**Re: 4071.10 – The Asylum – Level III Development Review Application
Response to City Staff Comments**

Below are our responses to staff comments that you provided to us on April 14 for the proposed Asylum project.

Re: 121 Center Street – The Asylum (2016-069)

Figure No. 2

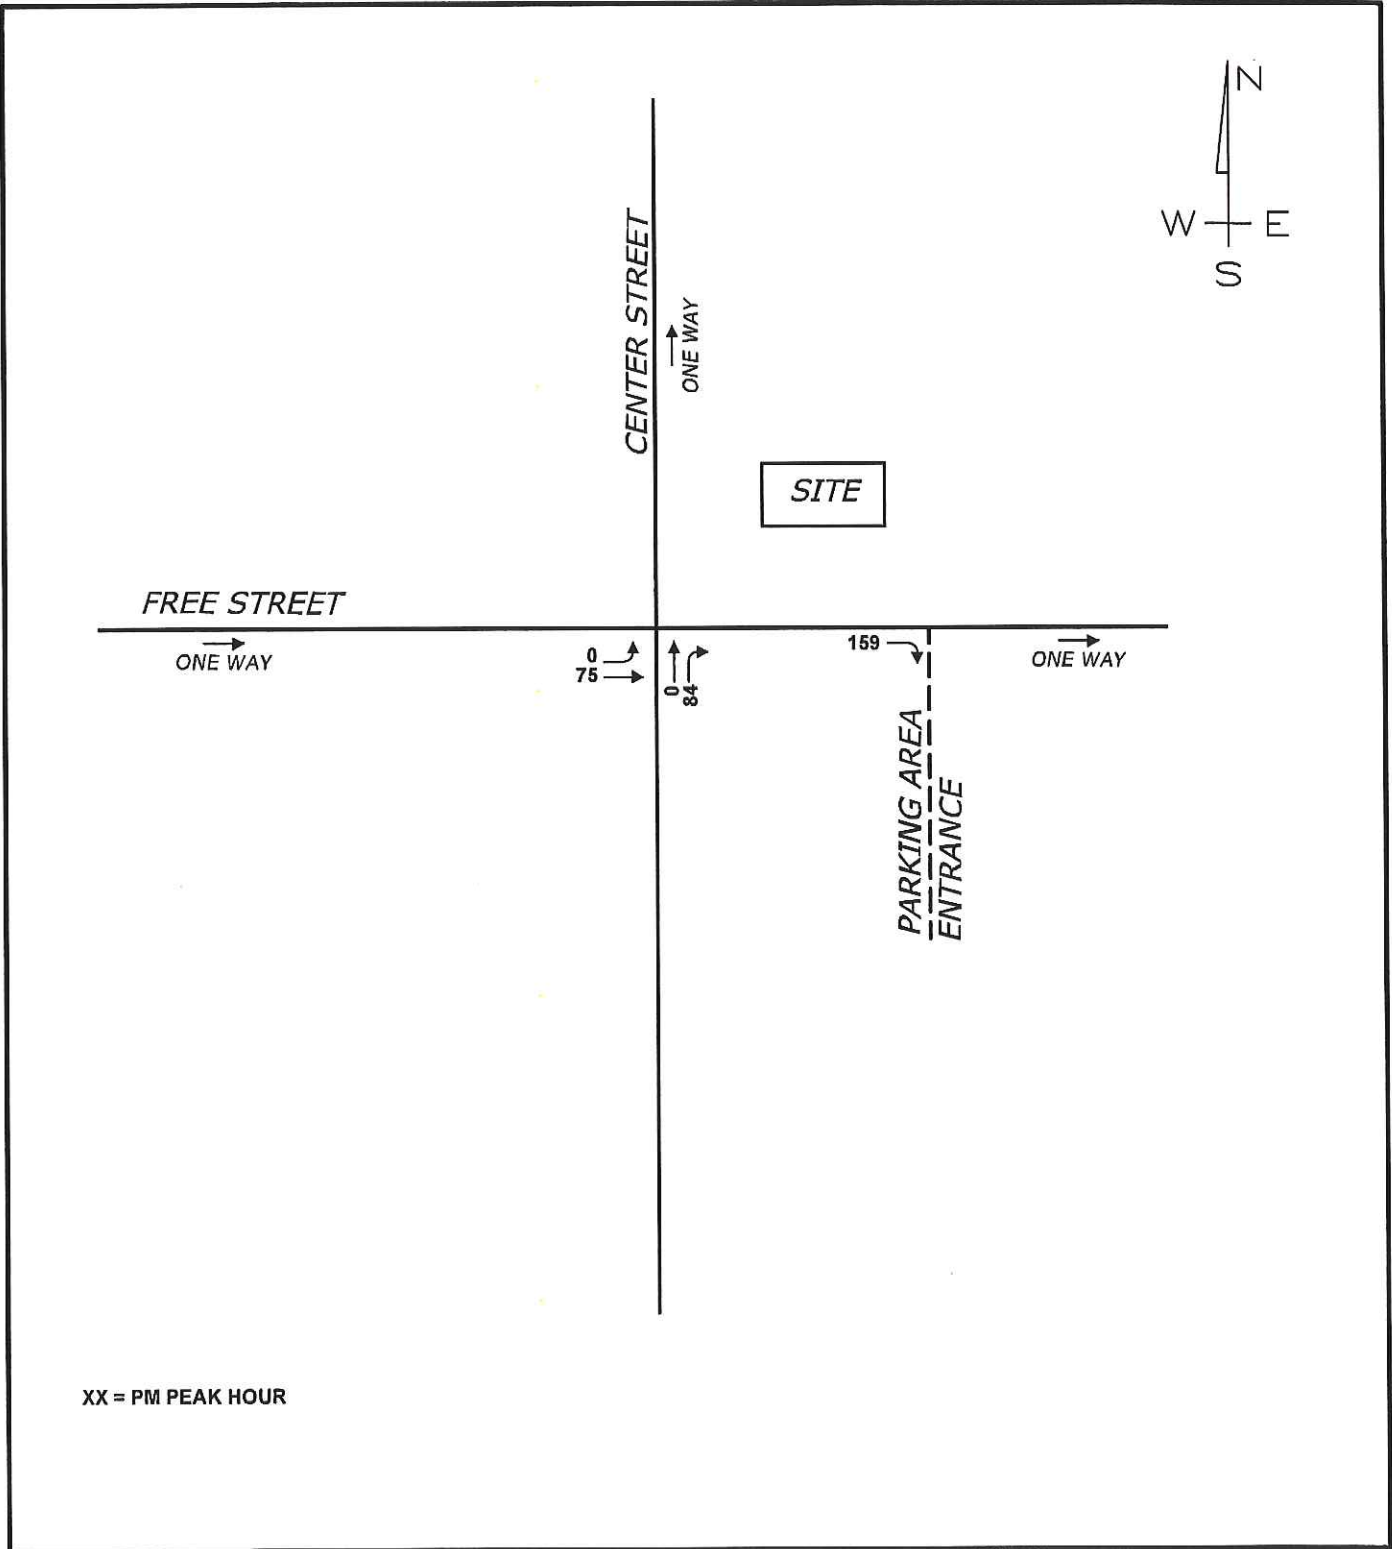
Gorrill Palmer (GP) has prepared this Traffic Movement Permit Application Addendum in response to comments received from the City of Portland and Mr. Thomas Errico at the MaineDOT scoping meeting held on May 2, 2016 at City Hall. It addresses the distribution of the forecast site traffic, additional collision data, and the potential for an all-way stop at the intersection of Free Street and Center Street.

The traffic forecast to be generated by the site was originally distributed based on the assumption that traffic would enter the site at Lancaster Lane and the existing traffic patterns at the intersection of Free Street with Center Street. Based on parking information received from WBRC, the site traffic distribution was reassessed to reflect the use of the identified parking area. The Asylum will be utilizing 60 parking spaces in the Midtown parking lot (bounded by Center Street, Free Street, Cross Street, and Spring Street), which will be guaranteed on event nights as coordinated by the Asylum's program director. The updated trip distribution assumes that all traffic going to the Asylum will utilize the manned entrance to the parking area on Free Street. This is a conservative approach, since the parking lot has other accesses that could be used, which would further dissipate the traffic over the adjacent roadway network. The distribution of the site traffic is shown on the attached Figure 2.
